**10 GLOUCESTER GATE, CAMDEN, LONDON, NW1 4HG**

**APPLICATION FOR VARIATION OF CONDITION 2 FOLLOWING GRANT OF PLANNING PERMISSION  
(2016/3706/P) – SECTION 73 OF THE TOWN AND COUNTRY PLANNING ACT**

**APPLICATION FOR VARIATION OF CONDITION 2 FOLLOWING GRANT OF LISTED BUILDING CONSENT  
(2016/4064/L) – SECTION 19 OF PLANNING (LISTED BUILDINGS AND CONSERVATION AREAS) ACT  
1990**

**Second floor of No. 11 Gloucester Gate illustrated in (LPA References:  
011/3152/P & 2011/3160/L) Plans**

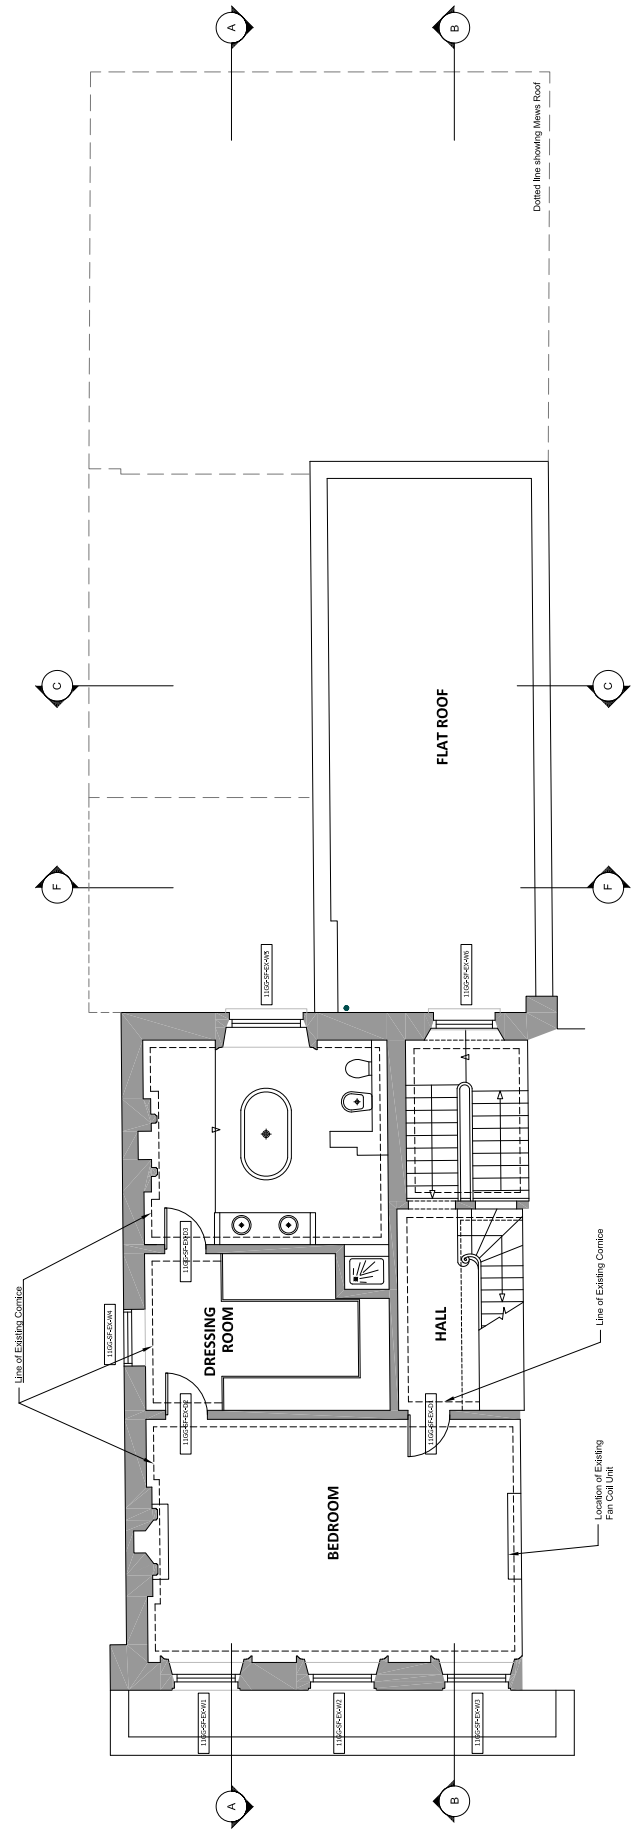
To add further justification, we note that a similar arrangement exists in the neighbouring property at No. 11 Gloucester Gate (Enclosure 1). We have appended the second floor plan which was illustrated as part of the permitted scheme of 2011 (LPA References: 2011/3152/P & 2011/3160/L).

2nd FLOOR

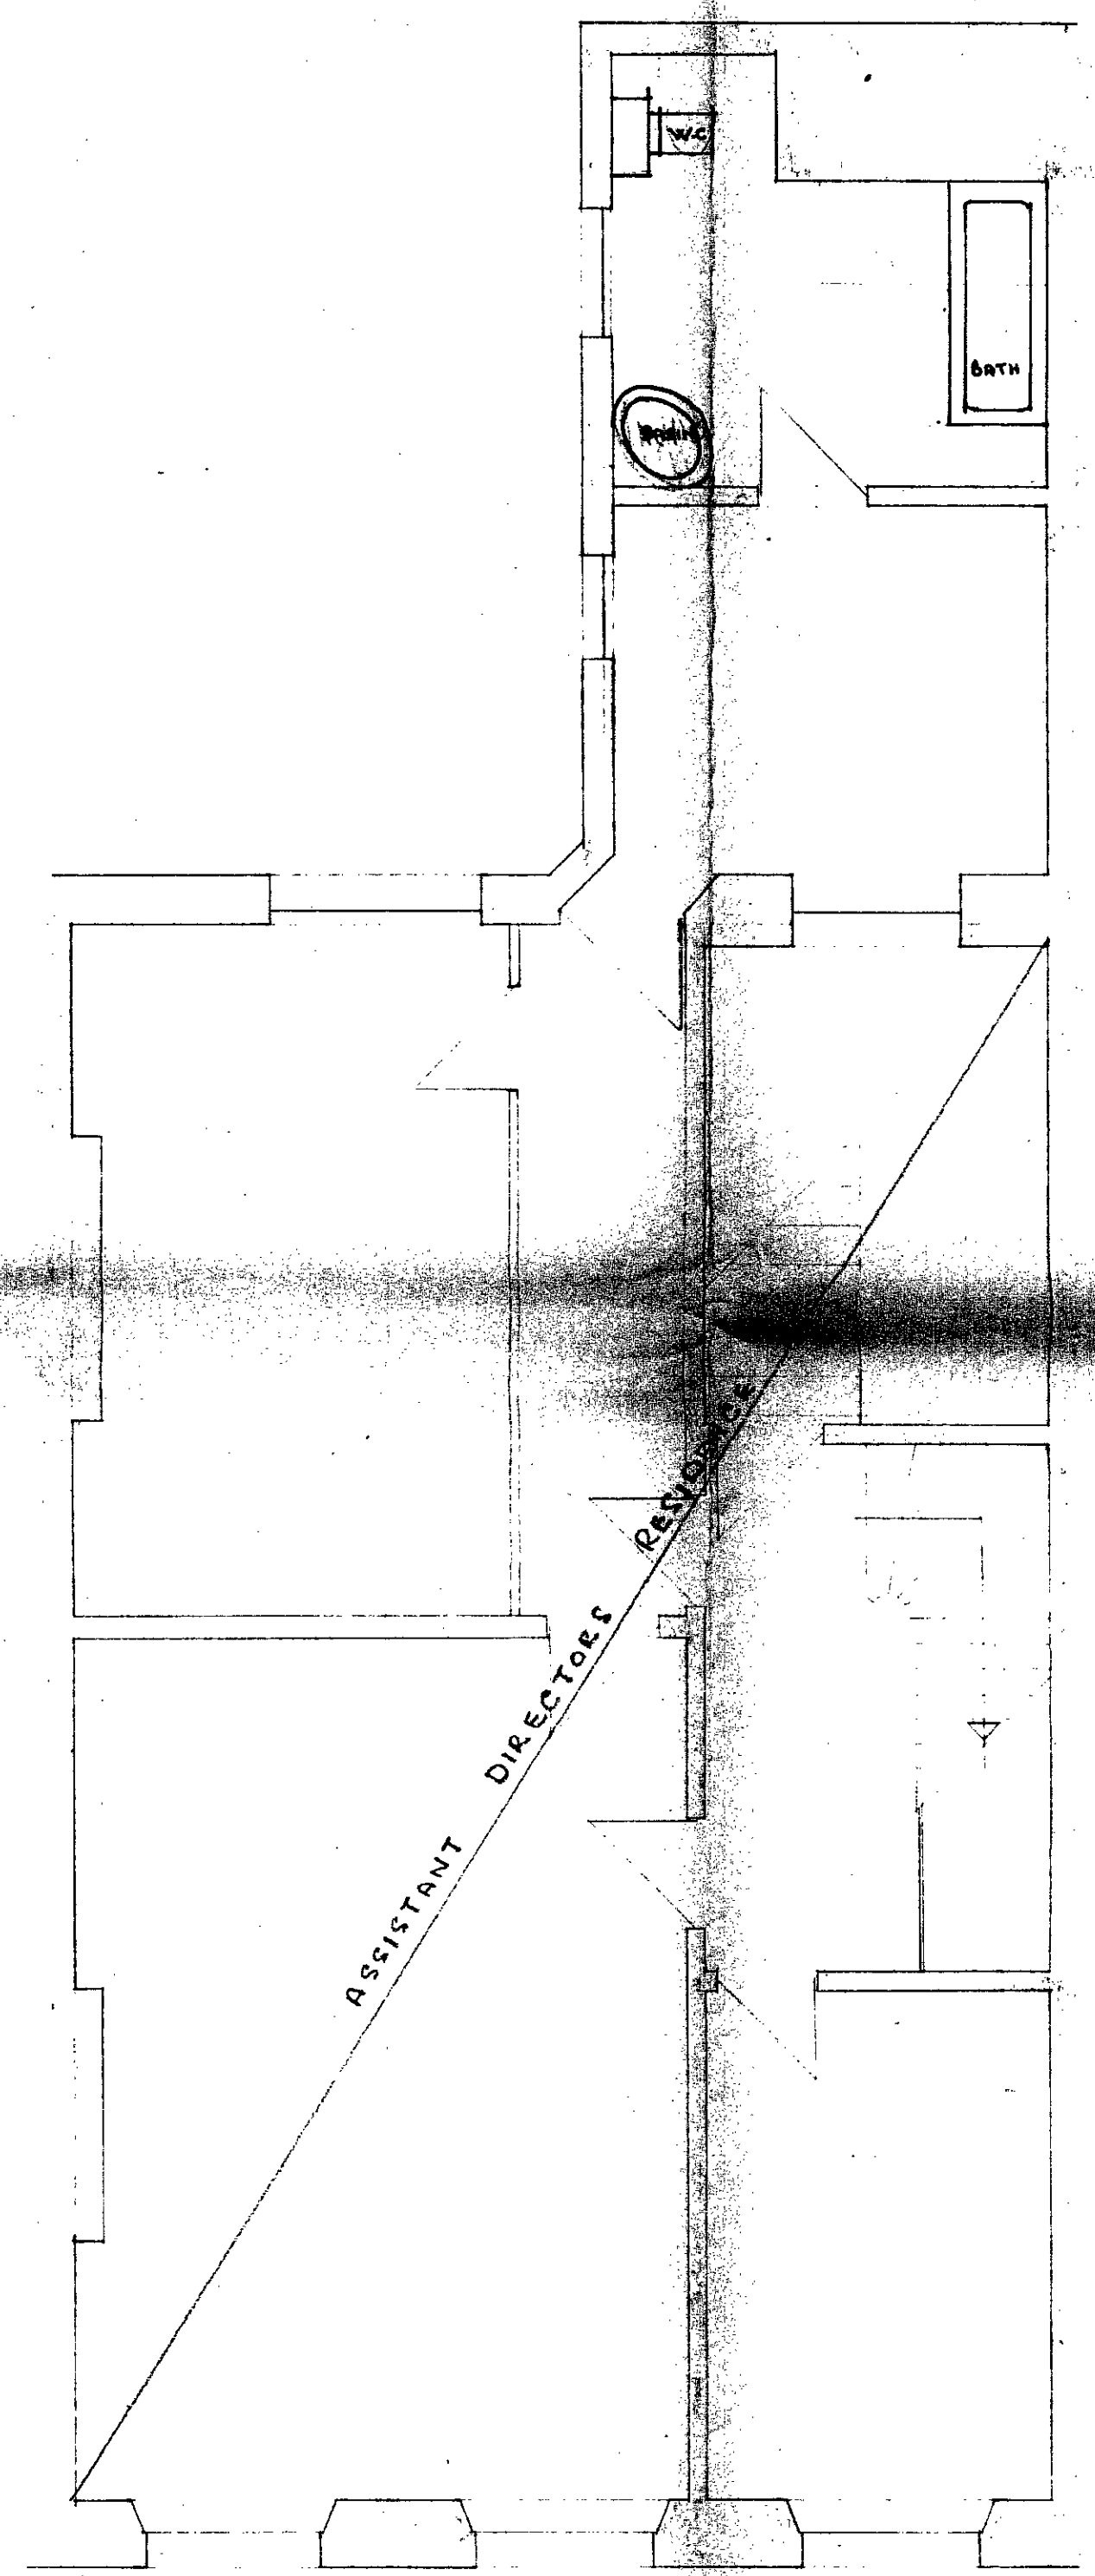
Through the process of undertaking investigative works, and re-examining the historic plans of the building, it is apparent there was formerly an opening to the bedroom from the stair landing in the eastern wall of the dressing room.

A survey of 1973 suggests such an opening was established by that date (Enclosure 2). Re-instatement of the doorway would not result in the loss of any historic fabric and would, simply, reinstate a previous phase of the building's history and provide an opening at an appropriate location for the type of building and level within the house.

To retain a single entrance into the bedroom, it is intended to block the existing door in the south wall. We consider this change to be minor and that the proposed works would preserve the special interest of the listed building.
